| Design Change Package | | | Z3103 |
| Form 5 | Document Change Notice (DCN) | Page 1 of 1 | |

DCN No.: 0000065 Page 1 of 135

The existing feedwater line for loop B inside containment has been redesigned & reanalyzed in conjunction with the replacement of steam generator "B" for unit-2.

"BEFORE"
SG "B"

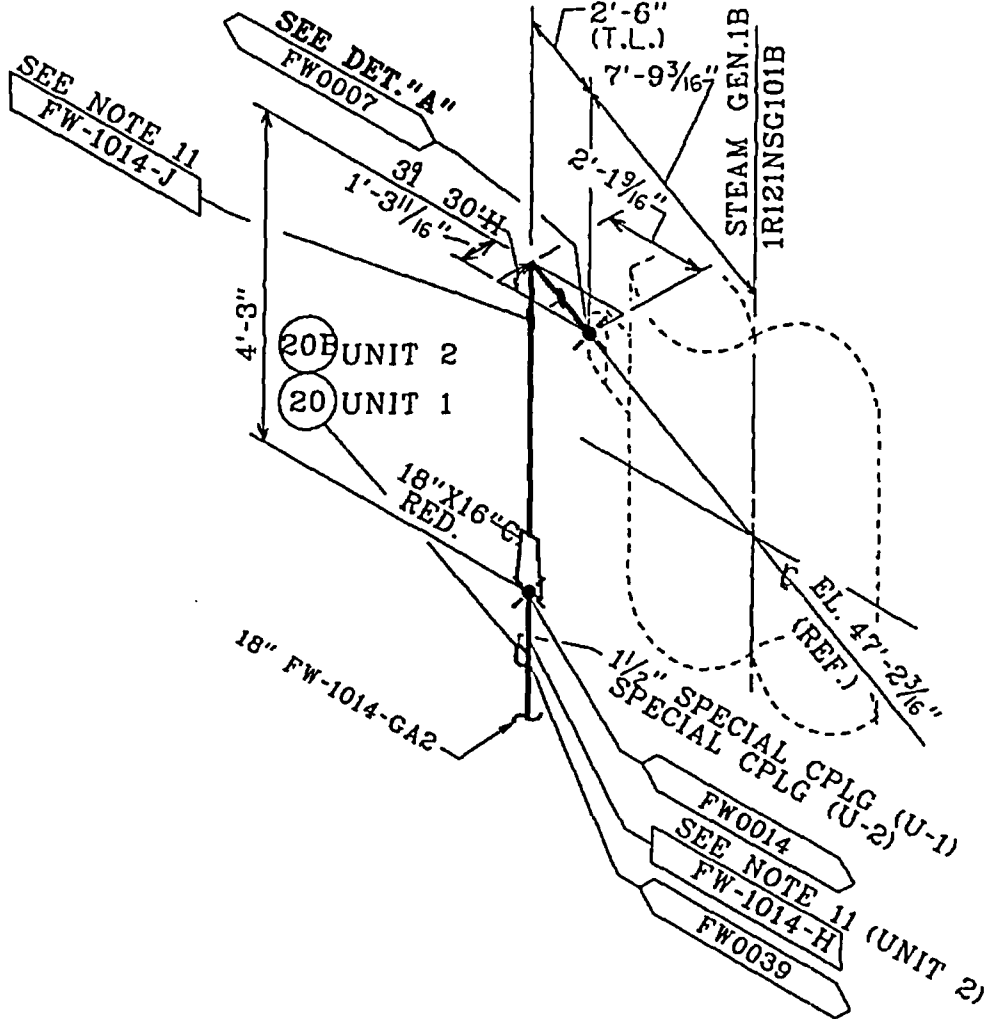
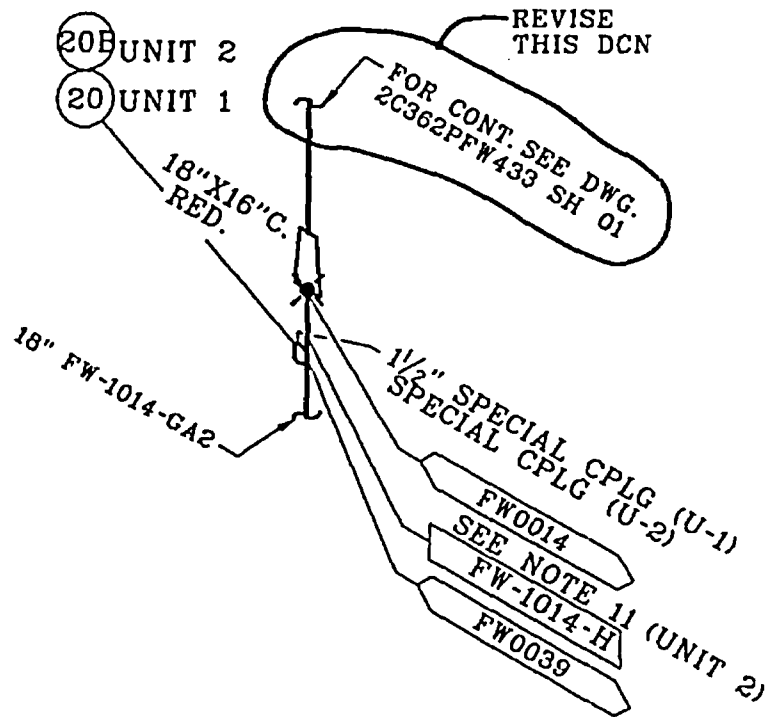
"AFTER"
SG "B"
